Barfoots of Botley Ltd, Sefter Farm, Pagham Road, Arun
Proposed Packhouse
(Application Reference: P/117/21/PL)

Highgate Transportation provided a Transport Statement (HTp/2167/TS/01, July 2021) to support the application for the proposed packhouse on land at Barfoots's Sefter Farm site, Pagham Road, Arun.

TITLE:
**INDICATIVE ROUTES
OF HGVs THROUGHOUT SITE**

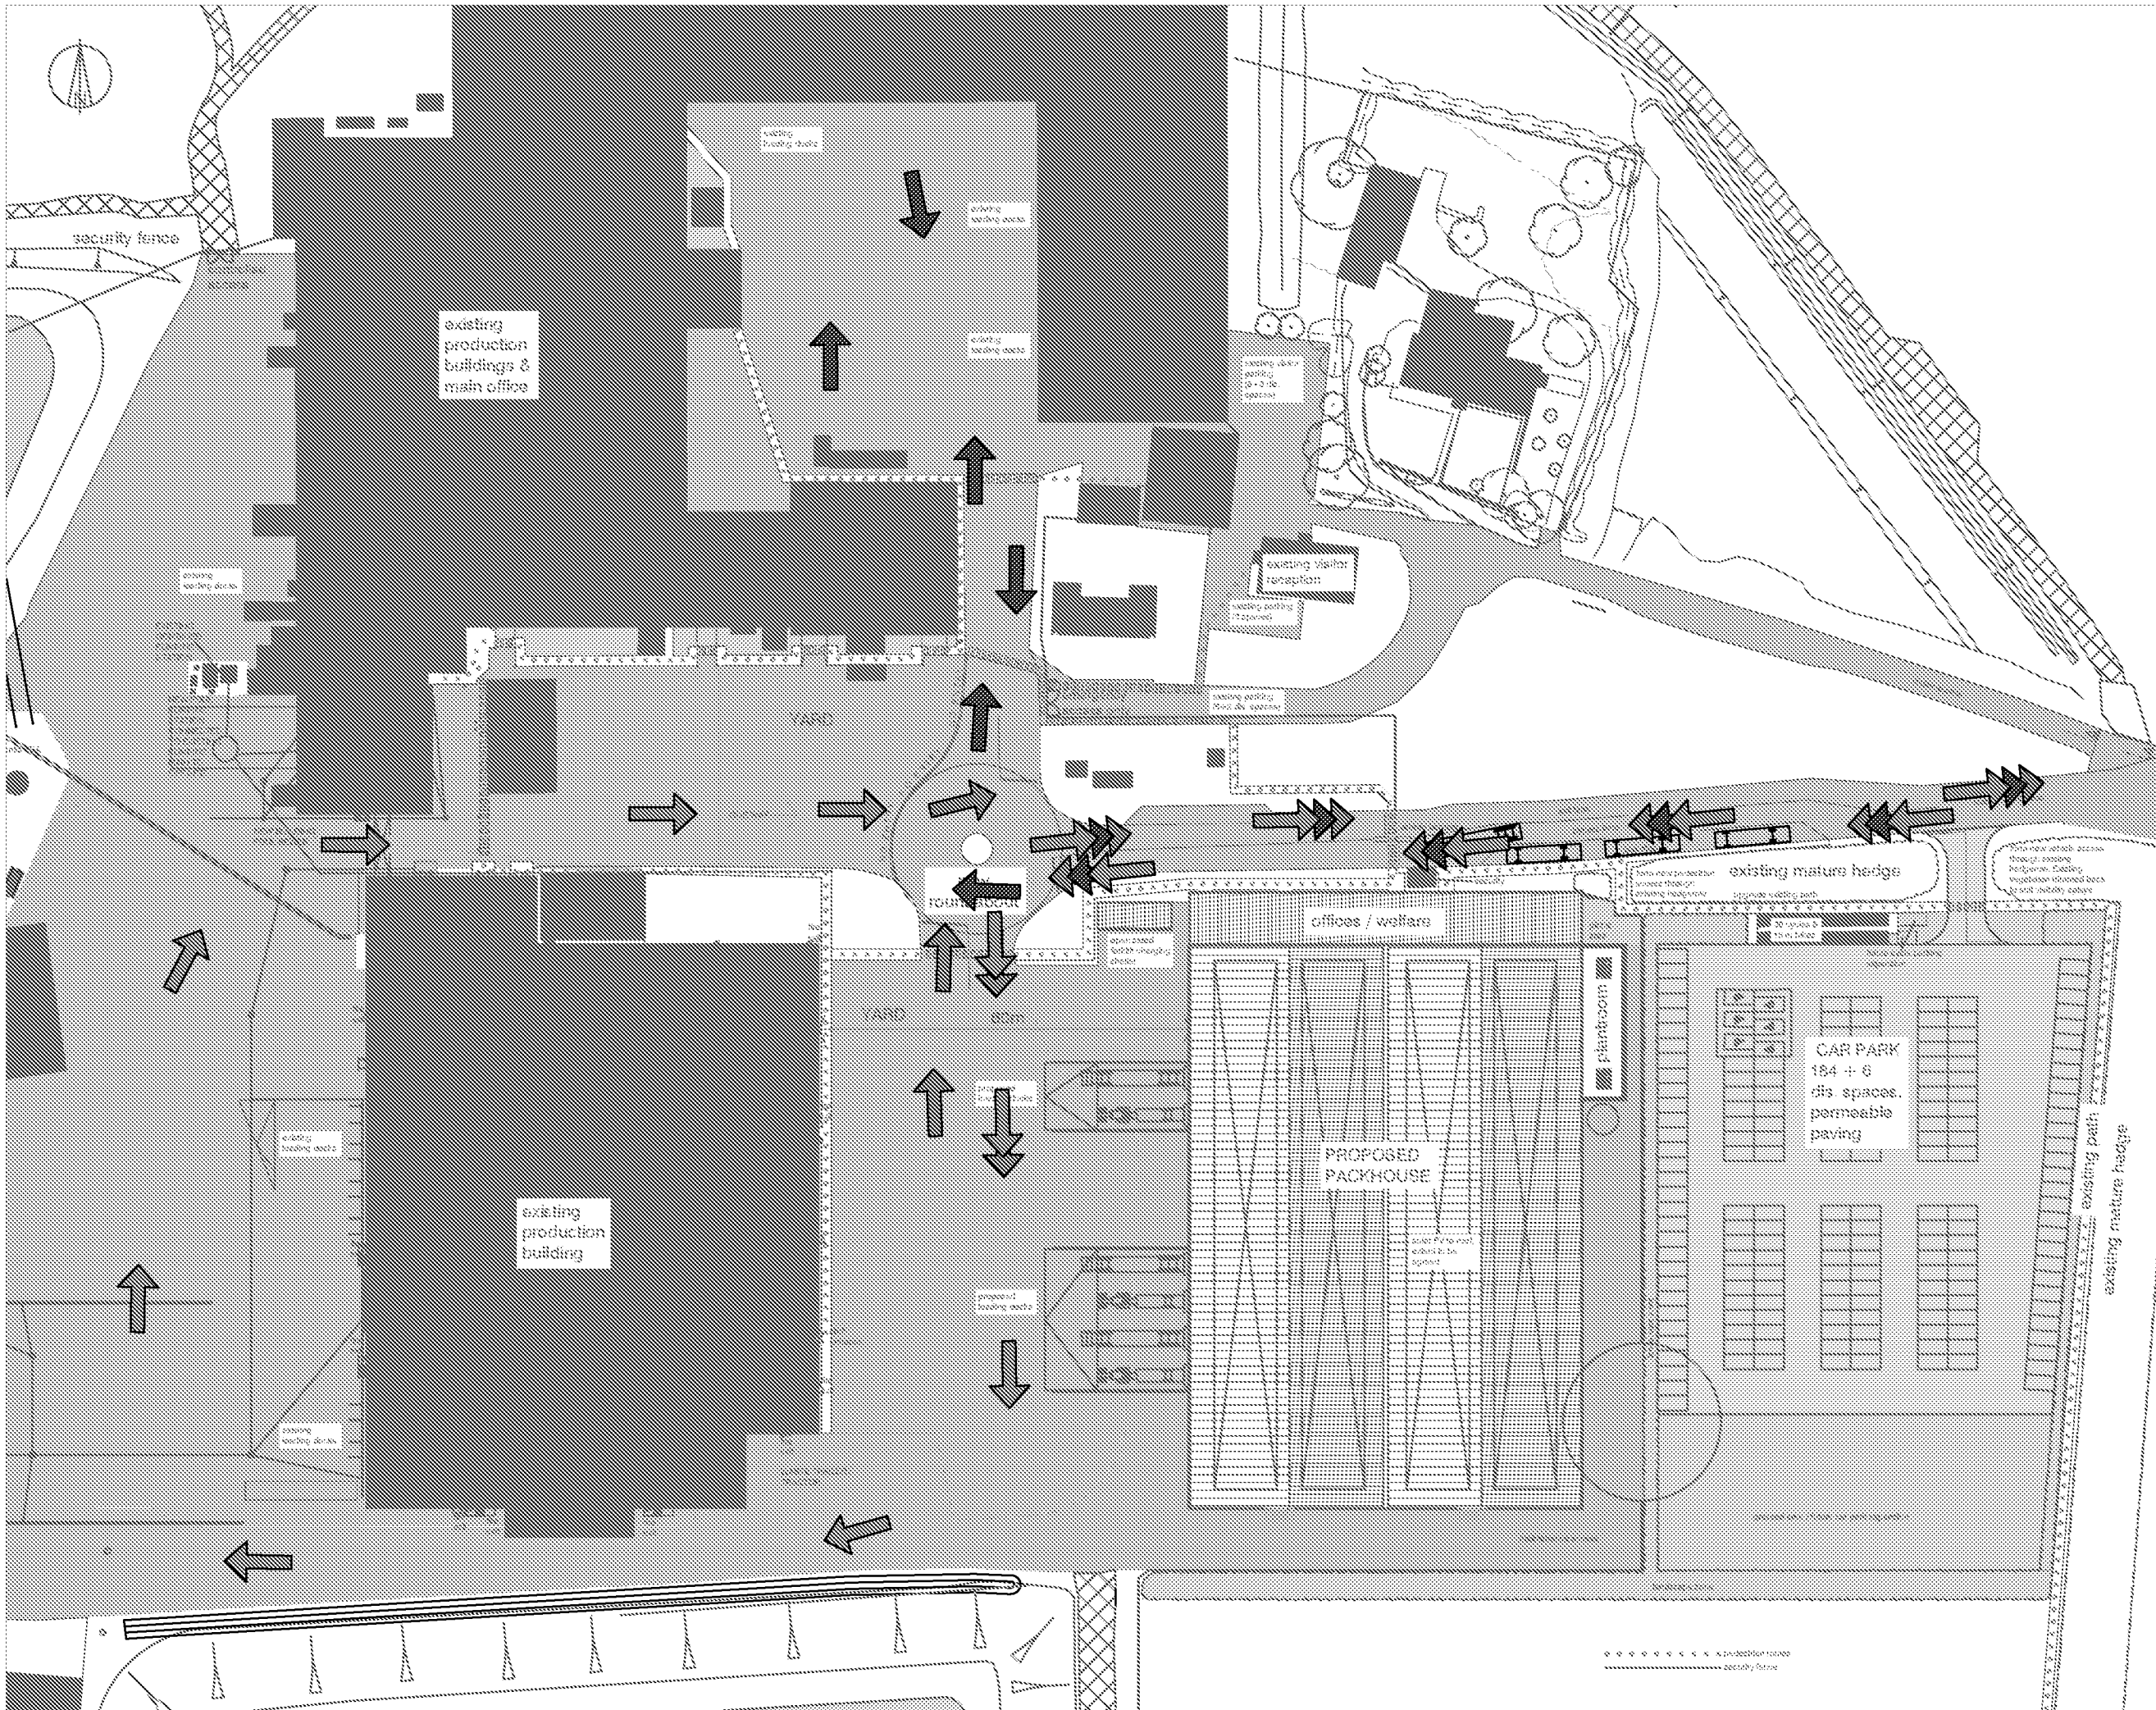
To understand the rearrangement of storage on site and impact on vehicle routes it would be useful for plans to show HGV routes throughout the site.

The highway officer has requested plans showing the HGV routes throughout the site to understand the site layout rearrangement and the impact this will have on vehicle routes. Plan HTp/2167/03 is provided at **Appendix 4** to demonstrate the HGV routes through the site.

LOCATION OF
ON SITE CAR PARKING

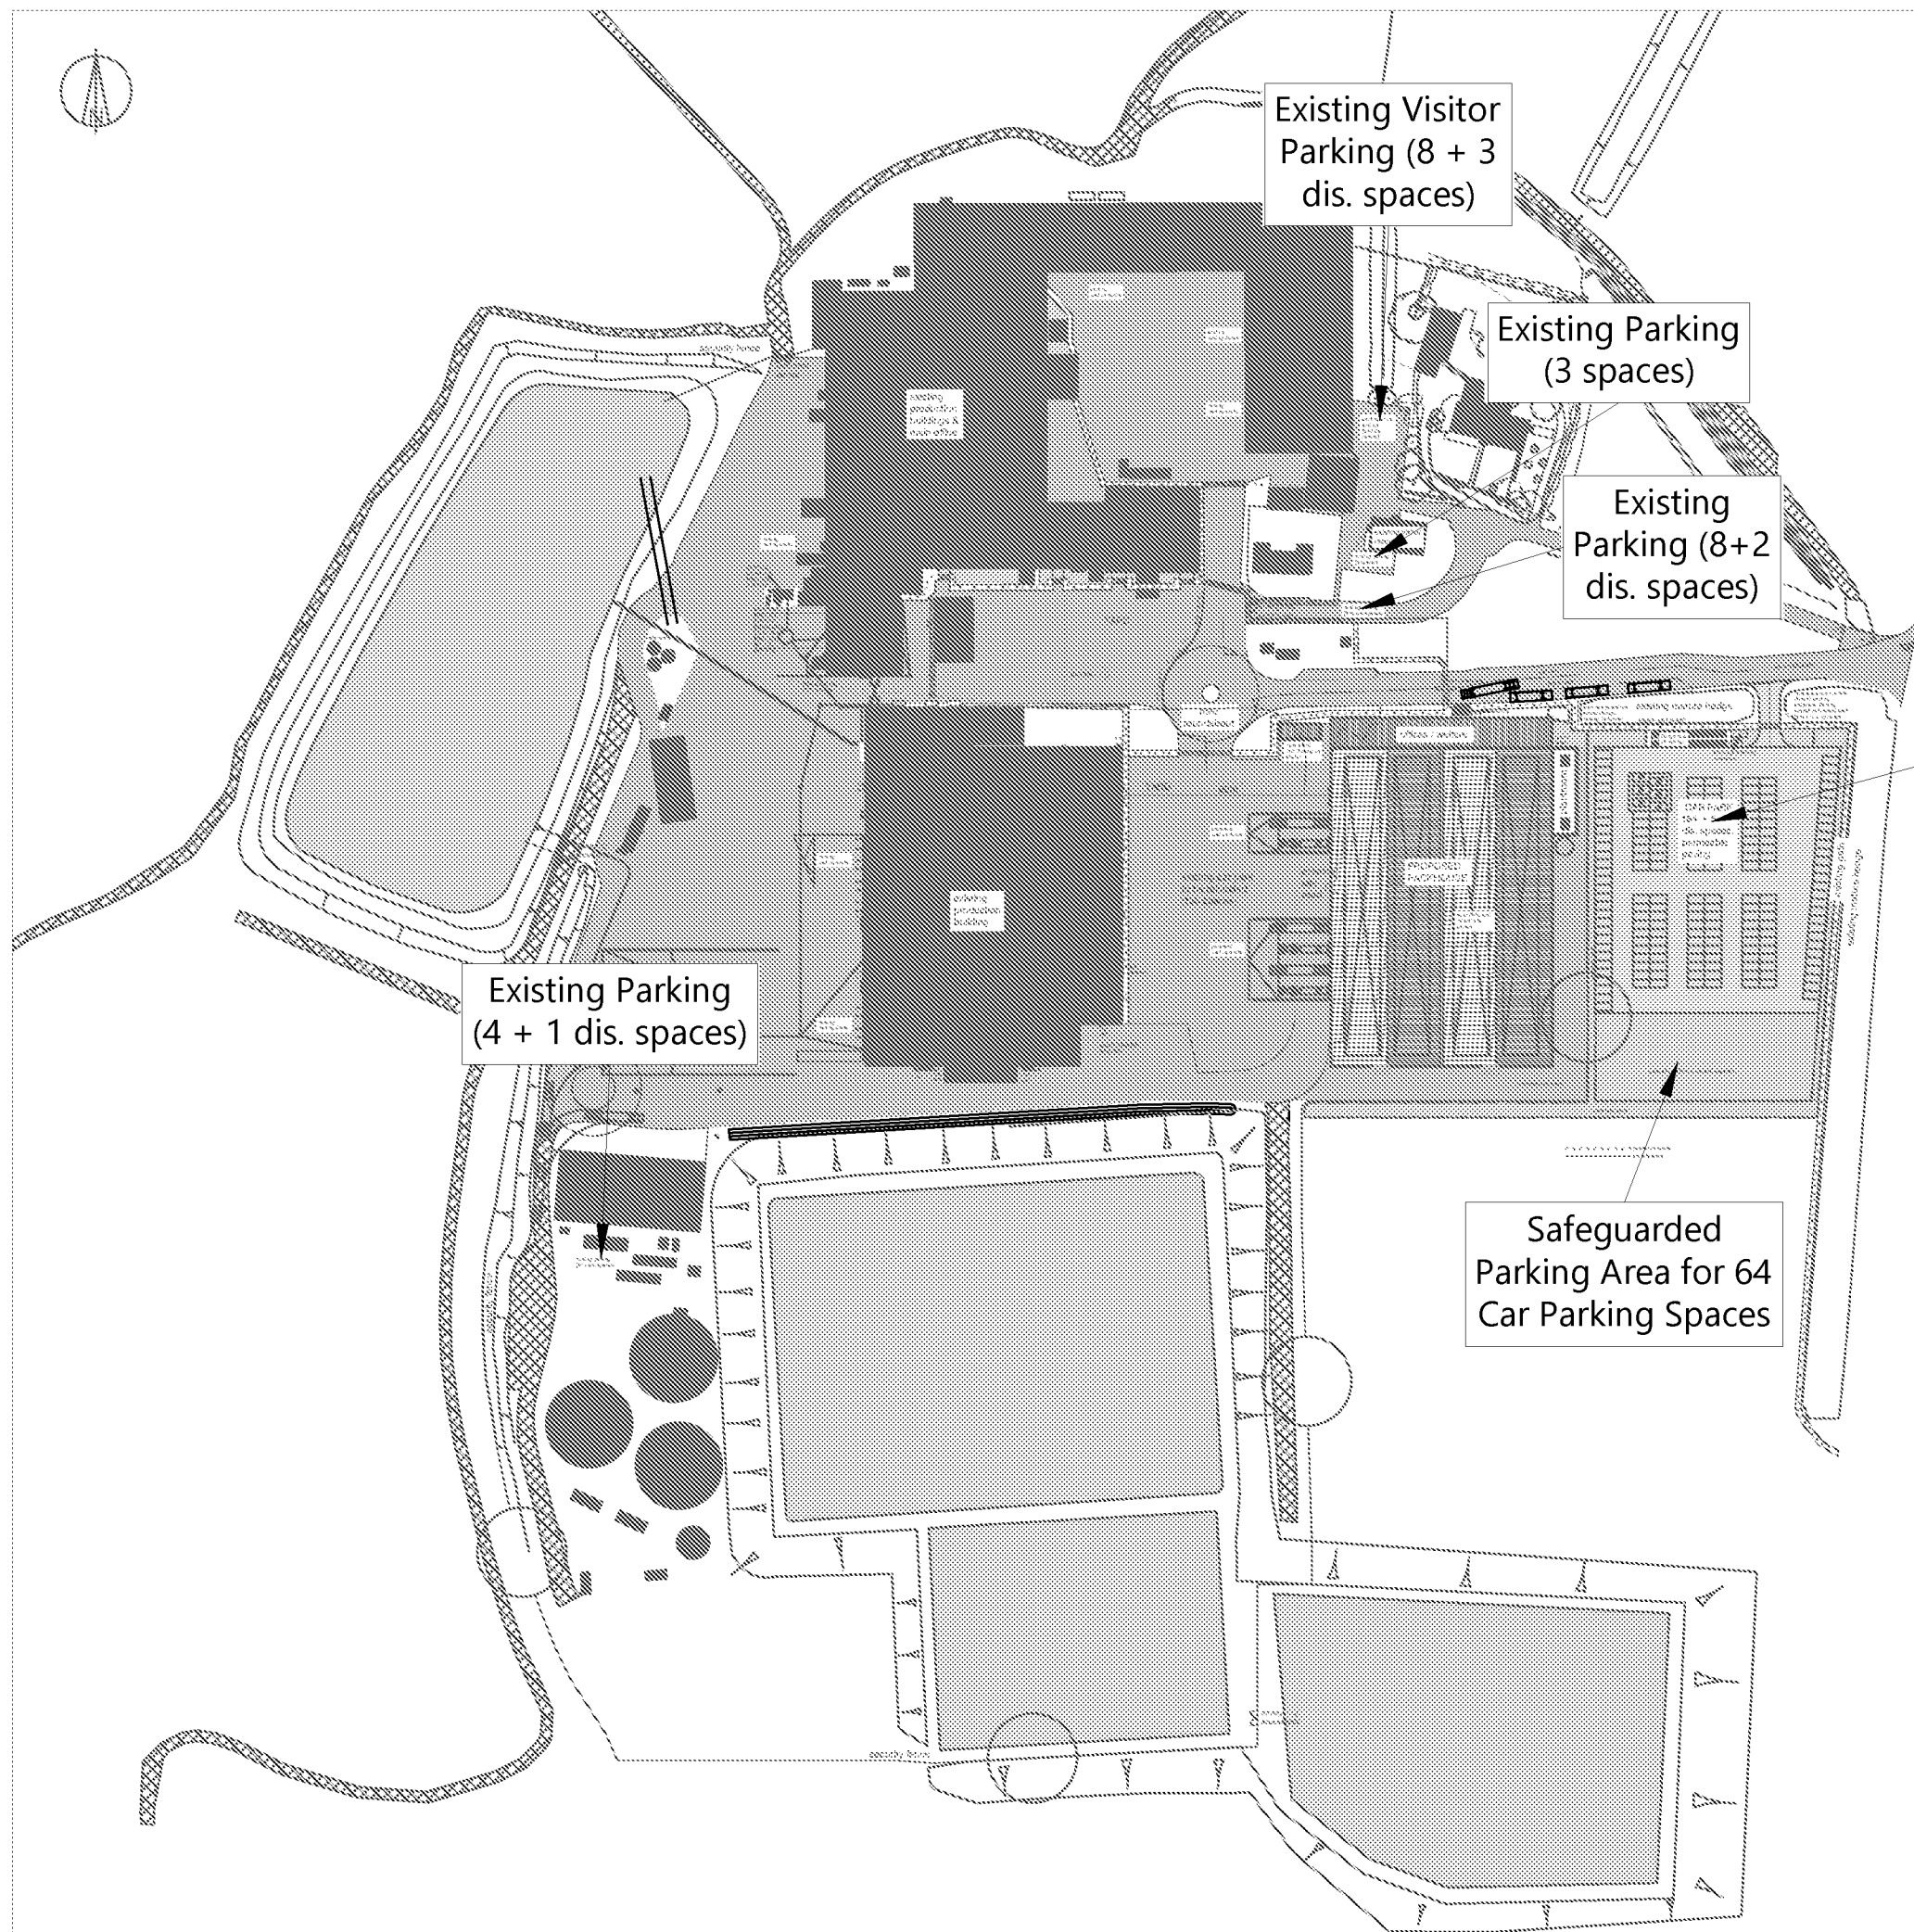
The existing car park will be relocated and visibility splays of 2.4m by 25m (20mph) from the car park access to the internal site road have been demonstrated. Tracking shows that cars can manoeuvre within the car park and pass in the access. It is stated that 219 spaces exist at the site in total although 190 are provided in the relocated car park it is not clear where the additional 29 spaces are located. Whilst it is noted that no new staff are proposed, it would be useful for each existing and proposed building floorspace to be set out against the required parking standard. It would also be beneficial to understand proposed storage only floor area of the new building and justify how the amount of space provided will meet all storage needs on site omitting third party movements.

The car park relocation requires the existing 219 spaces to be moved to the east of the new packhouse unit. While the TS states that there will be no increase to staff and no new trips forecasted, this has not been demonstrated given the proposal should be considered as a new B2/B8 unit. However, Arun District Council's parking standards dictate that one parking space is required per 100sqm. The development comprises

If it is intended that the 64 spaces not be provided, a car parking accumulation study should be carried out to confirm that the 219 spaces can adequately accommodate the forecast traffic generation from the proposed land use without the need for the additional 64 spaces.

The highway officer has asked for confirmation of where all 219 car parking spaces are located. Plan HTp/2167/04, contained in **Appendix 5**, annotates where the existing 219 car parking spaces are provided and where the safeguarded parking area for 64 car parking spaces is located.

I can also confirm that the current car parking facilities on site are not at capacity. Currently, 219 marked car parking spaces are provided throughout the site. As part of this application for the packhouse extension, it is proposed to relocate 190 car parking spaces (i.e. the existing main car park) to the new car park with the remaining 29 car parking spaces being retained in their current locations. A plan HTp/2167/04 has been provided to demonstrate the car parking on site.
